BOARD ACTION REPORT – APPEALABLE ITEM

Project Name: Cove 4
Project Location: 344 Venetian Drive
Request: Approval of a Class V Site Plan Modification
Board: Site Plan Review and Appearance Board
Meeting Date: October 10, 2018

---STAFF REPORT---

ITEM: **344 Venetian-Cove** 4: Class V Site Plan, Landscape Plan and Architectural Elevations for 344 Venetian Drive to construct a four-unit condominium (2018-134)

EXISTING TREE LIST

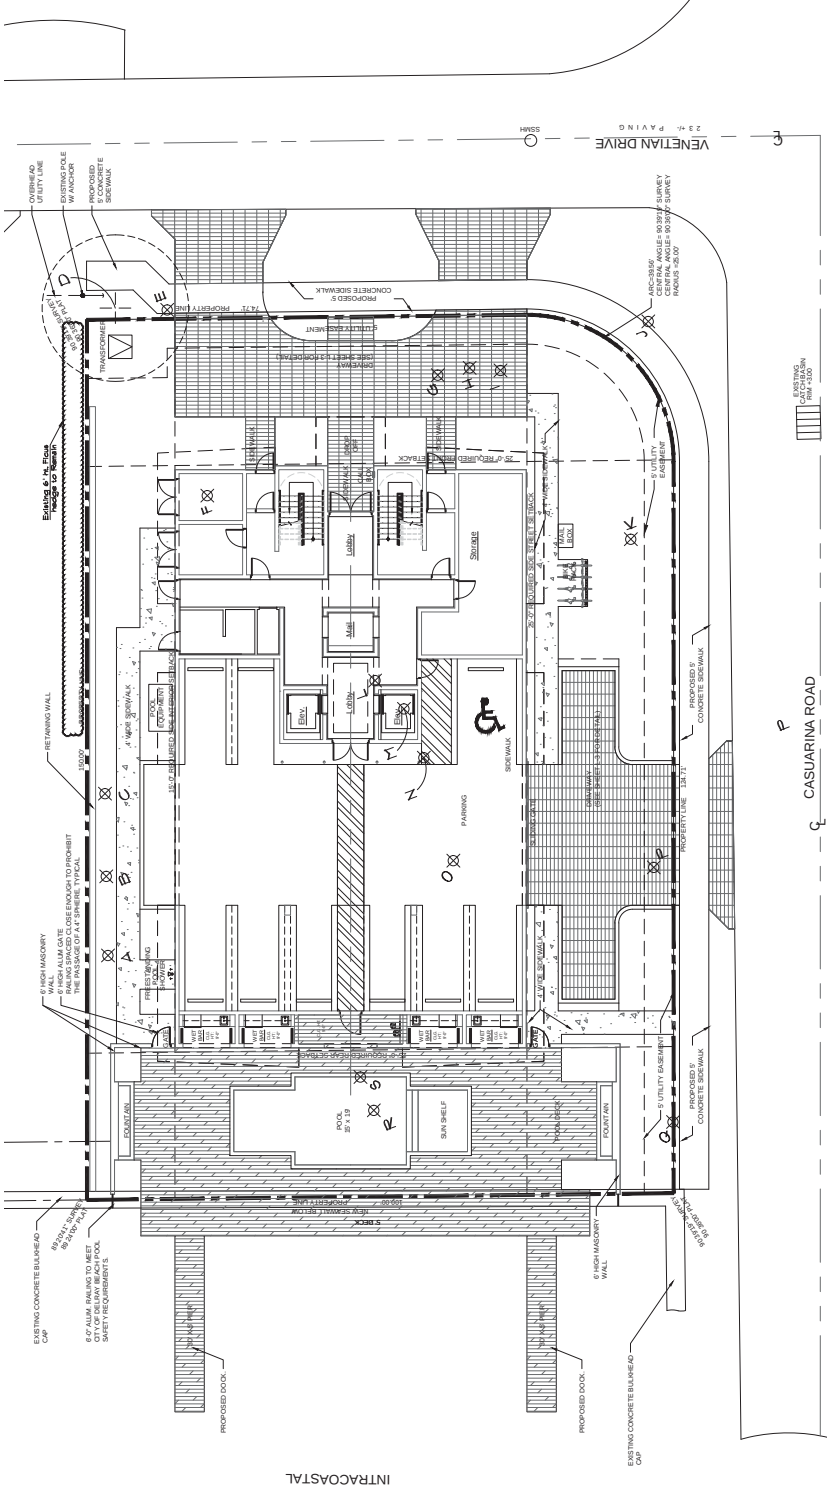
1. That the Condominium documents be submitted to the Planning and Zoning Department prior to building permit issuance.
2. Prior to site plan certification, the mitigation plan for trees to be removed will be added on Sheet L-1 on the "Existing Tree List".
